SERVICE BULLETINS

Number	Subject
AG. 1.A.	Filling a new Automatic Gearbox
AG. 5	Front and Rear Service
AG. 6	Rear Pump and Services (any)
AG. 7	Summing Points
AG. 8	Removal and replacement of the Automatic Gearbox
AG. 9	Tools. Front BAND SETTING Gauge
AG. 10.	Automatic gearbox front Servo Adjusting Gauge.
AG. 11.	" " Leaks
AG. 12.	" " DISTRICTS
AG. 13.	Loosening of Torus Cover Set Screws. Oil Leaks
AG. 14.	1000 mile service.
AG. 15	Torus Cover Gasket - W/1117
AG. 16	Dipstick Volume modification
AG. 17	Pressure Valve from pump Oil Seal - S2 Care
AG. 18.	Front band setting tool. UR. 3144
AG. 19	Vented Bell Housing Bottom Cover
AG. 19	Addendum. Vented Bell Housing Bottom Cover

EXPLODED VIEW OF GOVERNOR ASSEMBLY.

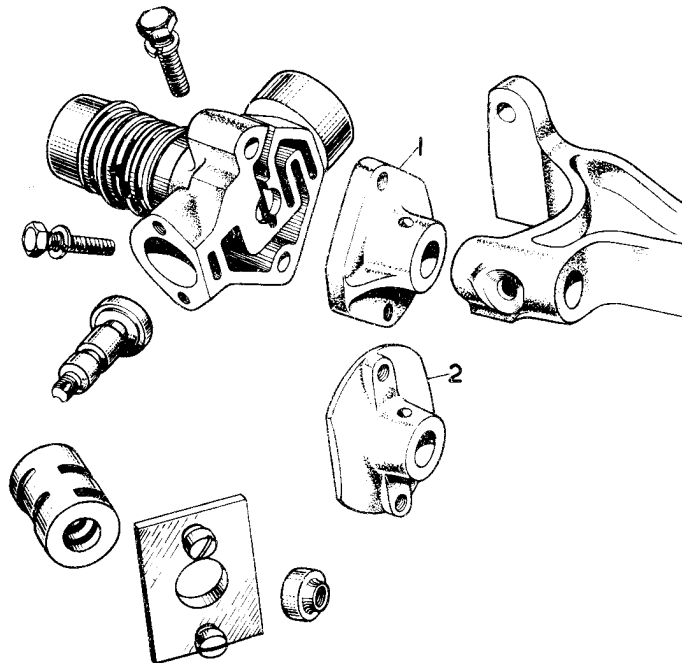
The governor driving flange in Automatic Gearboxes bearing the Serial Numbers C1 to C384 is in aluminium and has been superseded by a steel flange.

If it is necessary to service either the governor or the rear pump in these boxes, the complete governor and pump assembly should be changed for one containing a steel flange. It is not practicable to fit a steel flange to an existing shaft without the use of special equipment.

The illustration gives an exploded view of the governor assembly and shows both an aluminium and a steel driving flange.

Retailers are asked to keep a stock of the latest assembly, Part Number UG.1426, and to return any displaced assemblies as quickly as possible to the London Service Station for re-working.

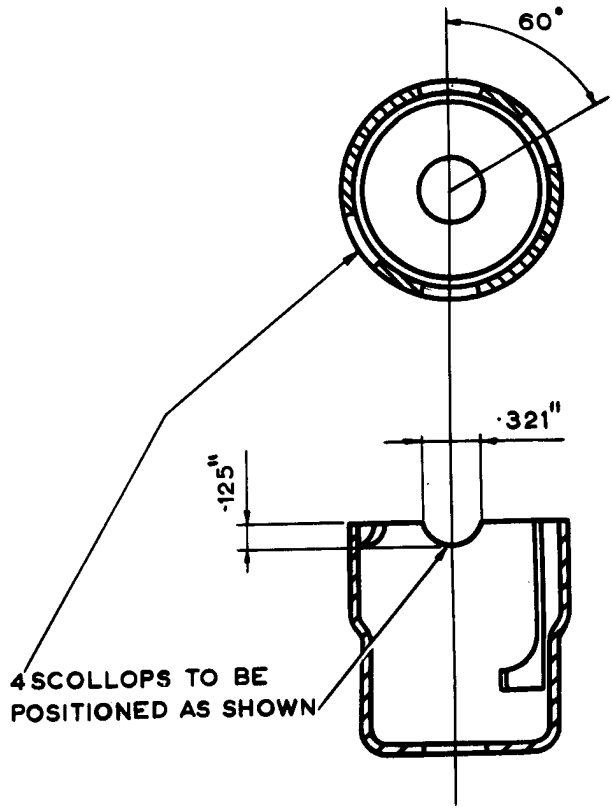
After prolonged running at high speed it may be possible for air pressure inside the gearbox to rise sufficiently to force oil through the normally satisfactory front pump oil seal.

This possibility is overcome by modifying the automatic gearbox oil breather and level indicator so that the pressure is relieved sufficiently to prevent oil leakage.

Take the oil breather and level indicator from the gearbox and carefully remove the retaining device securing the retaining cap to the indicator rod. The retaining device may be either a cee clip, spring clip, or split pin. This will allow the retaining cap, the copper mesh crimp and the serrated washer to be removed from the indicator rod. Cut the serrated washer and file the retaining cap as illustrated. Thoroughly clean and remove all metal particles, re-assemble the components and replace the assembly in the gearbox.

Fig.1.

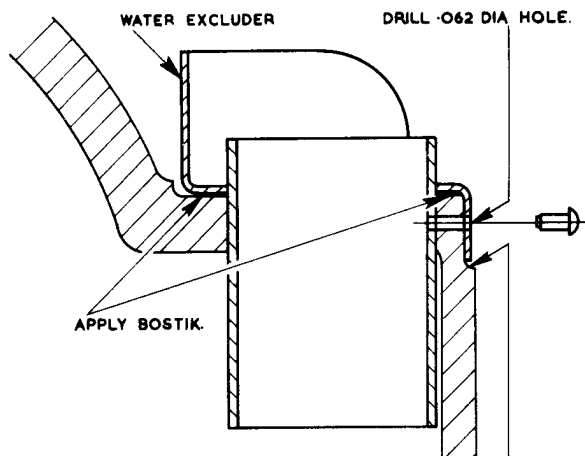
The following modification should be carried out to prevent water entering the gearbox by way of the dipstick aperture, only when the gearbox has already been removed for some other reason and is to be refitted into the chassis. All replacement gearboxes will incorporate this modification.

A small excluder in the form of a semi-circular shield is to be fitted around the dipstick guide, secured by a hammer drive hardened screw and sealed with Bostik to prevent ingress of water.

File a horizontal flat approx. 0.4" deep on the outside of the dipstick housing sufficiently deep to receive the right angled drilled location lip of the water excluder (see Fig. 1).

FILE HORIZONTAL FLAT .400 DEEP
TO RECEIVE EXCLUDER LIP.

Fig.2.

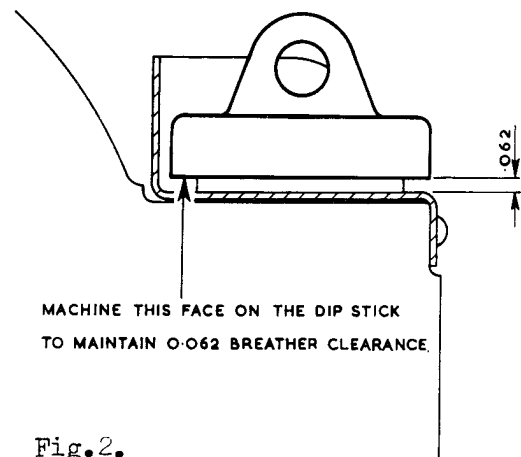
Machine the face of the dipstick as shown in figure 2 to allow 0.062" clearance for gearbox breathing. Clearly mark the top of the dipstick with RED paint to indicate that this has been carried out.

Fig.1. Pump Cover Checking Dimensions.

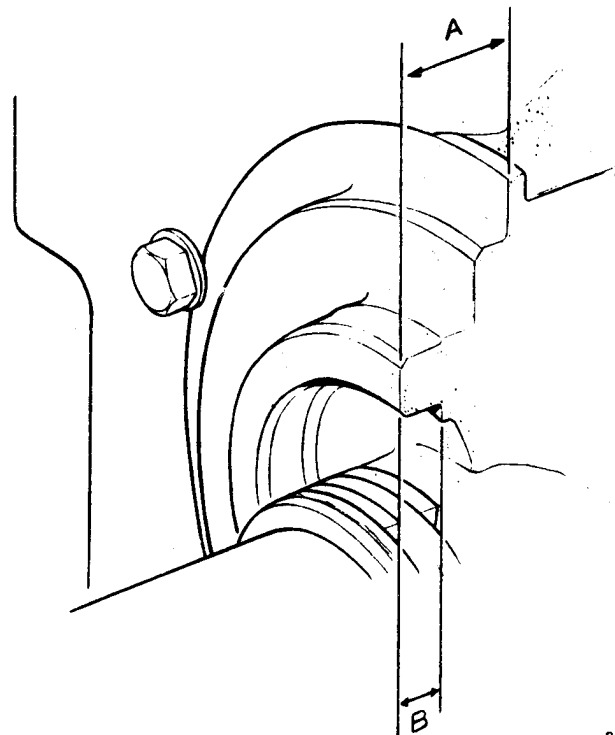
Difficulties have arisen concerning the fitting of the oil seal between the front pump cover and the torus cover. The following is a brief outline of the stages of modification in order of their introduction :

1. The seal fitted to S1 cars was pressed fully home into the annular locating recess. Early S2 cars had an identical seal (UG.3670), but this was not pressed fully into the recess. A modification was then introduced, interposing a washer between the seal and the recess end face in order to more effectively control the seal position.
2. A further modification incorporated the re-positioning of the seal recess on production pump covers so as to obviate the necessity for a packing washer.
3. Current S2 cars are being fitted with a new type of seal (UG.4107) requiring a recess position similar to that of stage 1 pumps. No packing washer is required and the seal is pressed fully into the recess so as to contact the end face.

Using a depth gauge or vernier callipers, measure dimensions 'A' and 'B' given in Figure 1. Subtract dimension 'B' from dimension 'A'. A result which lies between 0.355 in. and 0.400 in. indicates that the cover is not of the modified type and that a washer must be fitted; a result between 0.415 in. and 0.450 in. indicates a modified pump, requiring no action.

Machine the pump cover to increase the depth (Dimension B., Fig.1) of the seal location bore by .050 in. Thoroughly clean the cover to remove all swarf, and assemble the pump. Refit the unit to the gearbox.

Tool No. 27647/G.1002.

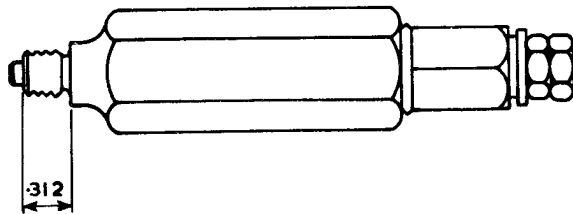
It has been found that due to a combination of manufacturing tolerances, that it is possible when using the front servo adjusting gauge for the end of the threaded portion to touch the servo piston, and so make accurate adjustment impossible.

As a guarantee against this happening, Retailers are asked to check that the threaded portion of these gauges (Part No. 27647/G.1002) conform to the dimension .312 as shown in the illustration below, and if not to modify by machining to suit.

Figure.1. Points between which dimension 1.160 in. is to be measured

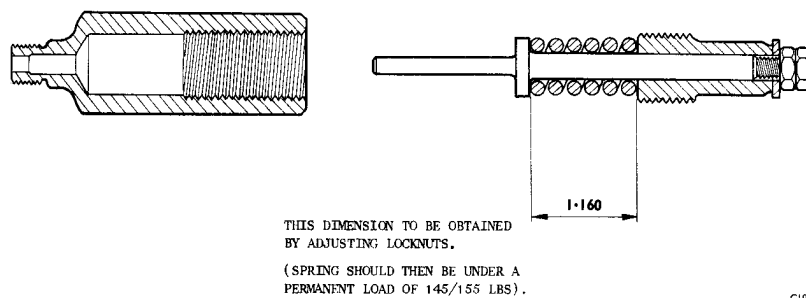
Service experience has shown that, occasionally, the locknuts, which control the spring loading in the front band setting tool UR.3144, slacken off thereby giving faulty adjustment of the front band.

It is therefore recommended that the front band setting tool should be checked for accuracy every 3 to 6 months, depending on how frequently the tool is used, in the following manner.

Remove the plunger assembly from its housing and check the length of the spring whilst under compression. The correct length is 1.160 in. \pm .003 in. between the two points indicated in figure 1. If the setting is found to be incorrect adjust the lock nuts accordingly. When the length is correctly set, peen over the end of thread to prevent any further slackening.

Fig. 1 Modifications to bell housing bottom cover

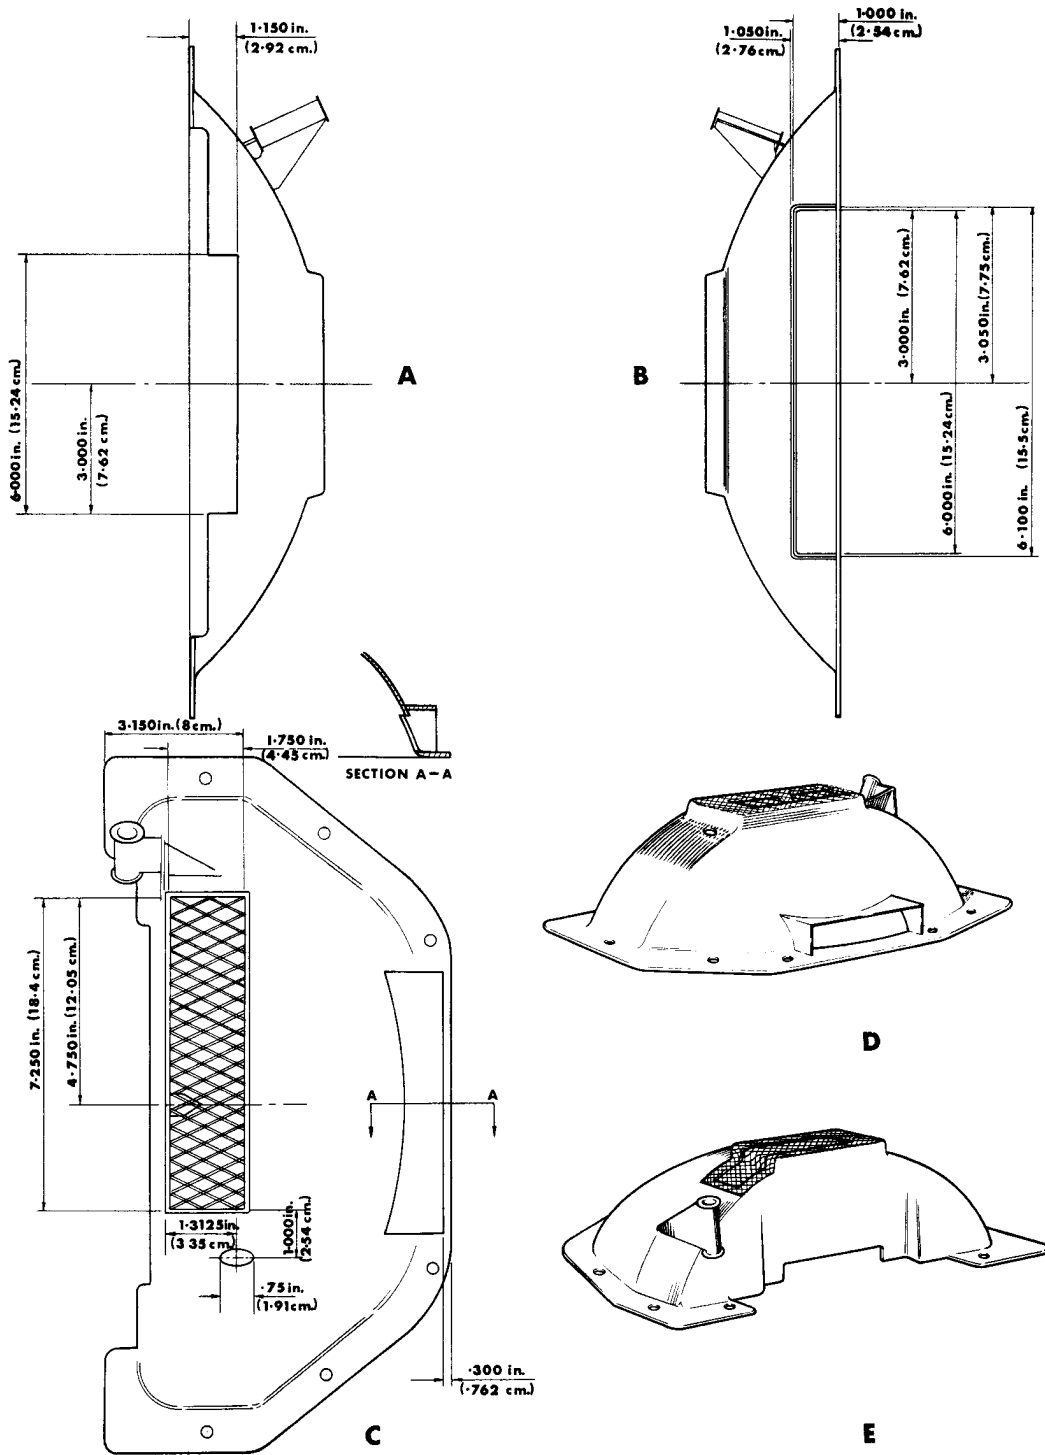
A number of recent complaints of slipping gearchanges and loss of drive in cars used frequently in congested town conditions have been attributed to overheated gearbox oil. It is known that the enormous number of gearchanges coming one after the other in conditions where there is negligible flow of cool air past the gearbox and bell housing, will maintain the gearbox oil at a very high temperature. The oil eventually oxidises, and thus reduces the coefficient of friction between the steel plates and the faced plates in the clutch packs. This causes slip, which heats the oil more and continues the vicious circle until the facing material of the clutch plates is attacked and disintegrates. Total loss of drive will follow. In service, this process of deterioration can first be recognised by slip at the 2-3 change, gradually extending to all the 'up' changes.

To ensure that the gearbox oil temperature remains below an acceptable level, a ventilated bell housing bottom cover will soon be fitted on production cars. This has two inlet ports for cool air close to the torus hub, and an outlet for hot air on the bottom of the cover screened with wire mesh.

Using the modification kit RH 2322 modify the cover as shown in Figure 1, working in the following order

1. Cut the inlet port in the front of the bell housing bottom cover working to the dimensions in view 'A', shown again pictorially in view 'E'.
2. Cut the inlet port in the rear of the bell housing bottom cover to the dimensions shown in view 'B'.

3. Fabricate a shroud and solder around the rear inlet port. The dimensions for this are shown in views 'B' and 'C', and the finished shroud is shown pictorially in view 'D'. Material should be of a similar thickness as the bottom cover.

4. Working to the dimensions shown in view 'C', cut the outlet slot in the base of the bell housing bottom cover, taking care to leave the timing pointer in position.

5. Solder the wire mesh panel, RH 7583, in position over the outlet port.
6. Drill or cut a 0.75 in. dia. hole as shown in view 'C' to enable the engine to be cranked over for timing purposes. Remove any burrs from the edge of the hole and insert plug RH 7585.

Figure 1 Oil cooler in position behind left-hand "snowpack"

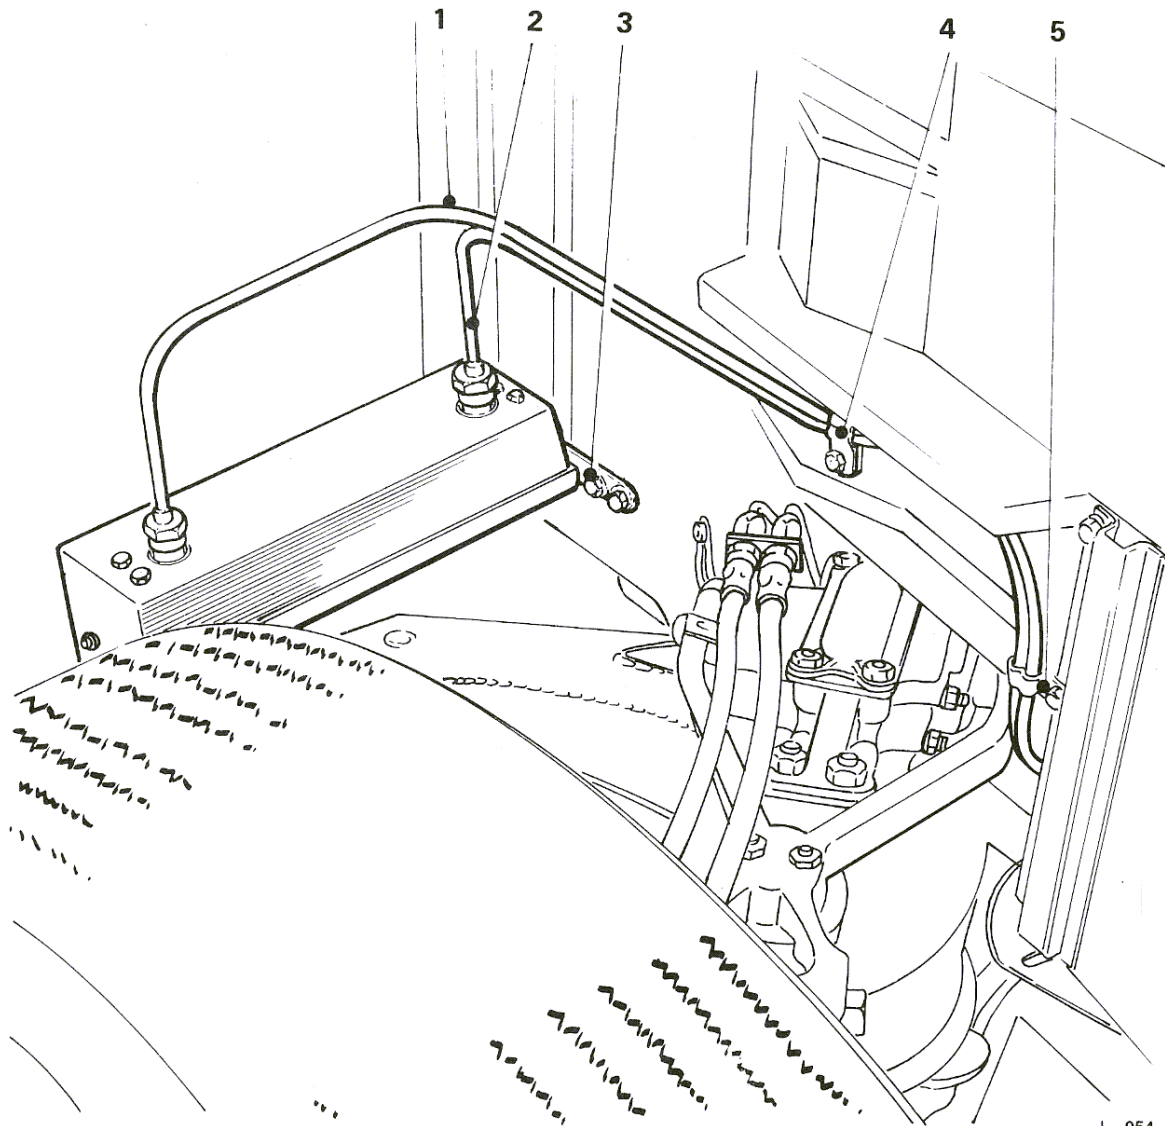
A number of recent complaints of slipping gearchanges in cars used frequently in city conditions have been attributed to overheated gearbox oil. The overheated oil causes slip between the clutch plates on drive take-up resulting in harsh and jerky gear changes.

To overcome this problem, a gearbox oil cooler has been developed and is now available in kit form.

3. Use the setscrew previously removed, locate the mounting plate RH.8360 (Figure 1 (1)) against the valance, and using this as a template, drill a hole 0.281 in. (7,1 mm.) dia. to the rear of the setscrew.
4. Fit the upper cover assembly (Figure 2 (2)) RH.8354, to the oil cooler (Figure 2 (5)) using four 0.250 in. (6,35 mm.) dia. nuts, bolts and washers as shown in Figure 2.
5. Attach the plate RH.8360 (Figure 1 (3)) to the left-hand side of the upper cover (Figure 2 (2)) using two 2B.A. setscrews and washers such that it protrudes horizontally from the rear of the assembly.

9. Fit the assembly beneath the wing.
10. Fit the pipe RH.8365 (Figure 1 (2)) to the inboard outlet on the cooler and the pipe RH.8367 (Figure 1 (1)) to the outboard outlet. Do not tighten the unions at this stage (see Figure 1).

11. Fit a clip (Figure 1 (4)) UR.14505 to the pipes on the vertical section of their run behind the damper and secure with the lower existing bolt supporting the forward edge of the engine access plate.

12. Fit the second clip (Figure 1 (5)) UR.14505 to the pipes at a point coincident with the alternator clearance indentation in the valance.
13. Using the clip as a template and supporting the pipes horizontally, carefully drill a hole 0.281 in. (7,1 mm.) dia. and secure the clip with a 0.250 in. (6,35 mm.) dia. bolt, nut and washer.

Figure 2 Exploded view of oil cooler assembly

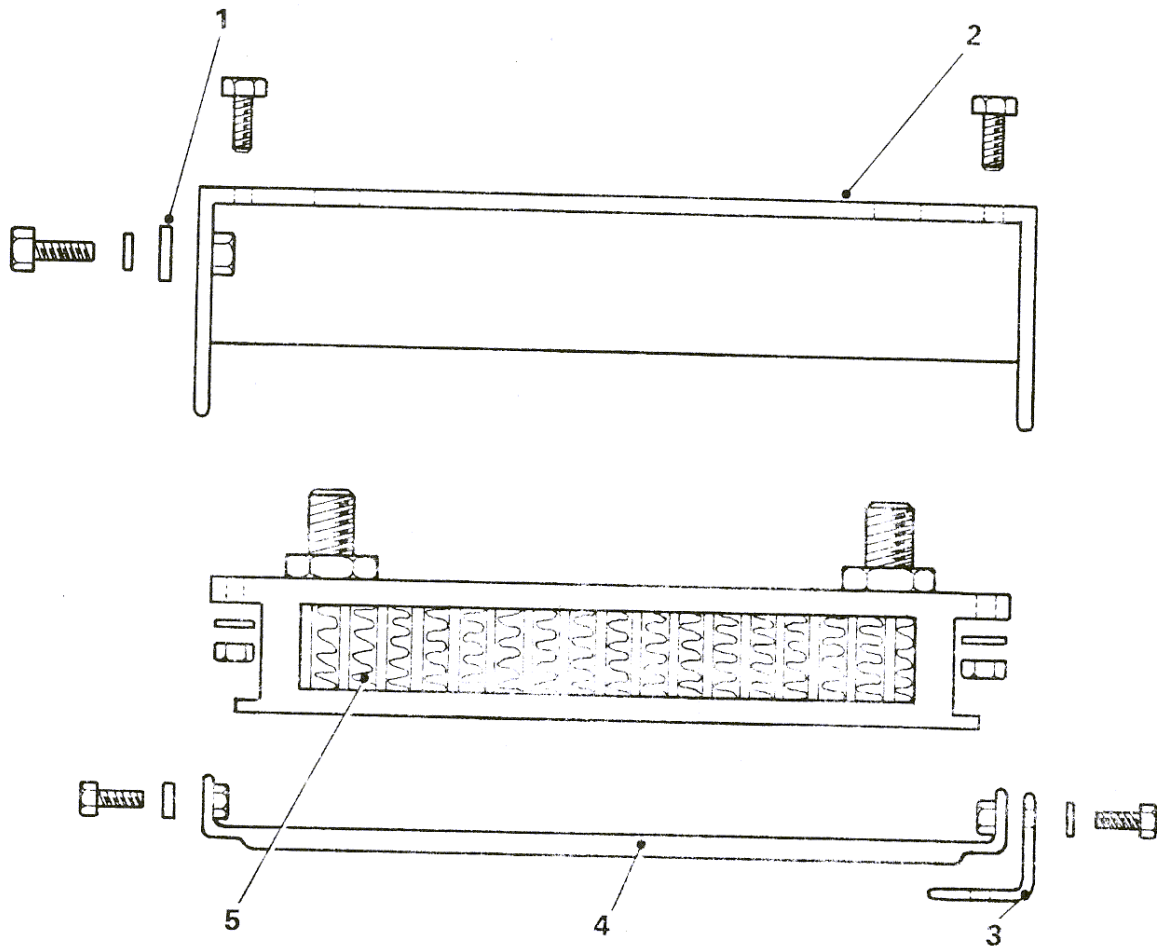
Note An exploded view of the oil cooler assembly is shown in Figure 2.

6. Fit the lower cover (Figure 2 (4)) RH.8357 and the right-hand support bracket (Figure 2 (3)) RH.8359 to the assembly with the ears of the lower cover inside the side pieces of the upper cover and the flange on the support bracket towards the front of the assembly. Secure with four 2B.A. setscrews and washers to the weld nuts in the lower cover.
7. Clean the area under the left-hand front wing behind the "snowpack" so that the oil cooler will be tightened and sealed against a clean flat surface.
8. Locate the assembly under the wing using the radiator bracket securing setscrew; check the position of the hole in the body flange below the oil cooler to ensure alignment with the hole in the support bracket (Figure 2 (3)). If alignment is not possible, drill a new hole 0.281 in. (7,10 mm.) dia.

Figure 3 Pipes fitted to gearbox

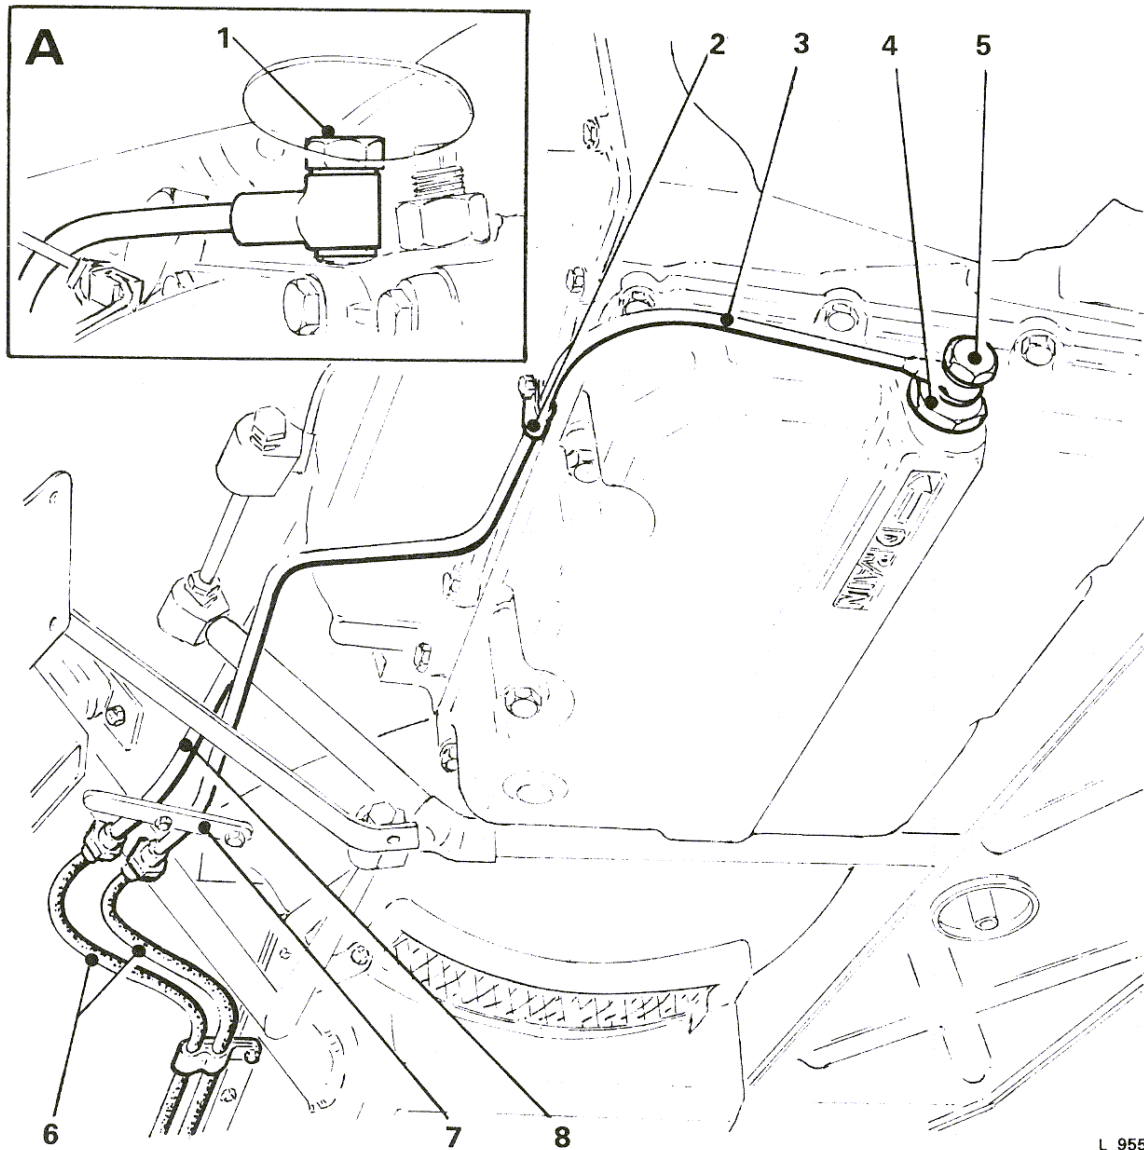
17. Fit the plate (Figure 3 (7)) RH.8376 to the gearbox bell housing using a 0.50 in. (12,7 mm.) dia. setscrew in the position shown in Figure 3.
18. Remove the square headed plug located between the two gearbox band adjusting screws.

19. Fit the pipe (Figure 3 (8)) RH.8371 to the tapping point using the banjo bolt restrictor (Figure 3 - Inset A (1)) RH.8375 and sealing washers as supplied.

20. Fit the adaptor (Figure 3 (4)) RH.8378 in place of the gearbox sump drain plug using sealing washers.
21. Fit the pipe (Figure 3 (3)) RH.8369 to the adaptor RH.8378 using the banjo bolt (Figure 3 (5)) RE.14445 and sealing washers.

22. Ensure that the forward ends of both pipes lie on top of the bell housing plate (Figure 3 (7)) and pass either side of the gearbox actuation linkage, the pipe (Figure 3 (3)) from the gearbox sump lying inboard of pipe '8' shown in Figure 3.

Clip the pipe (Figure 3 (3)) to the gearbox control box as shown in Figure 3 (2)).
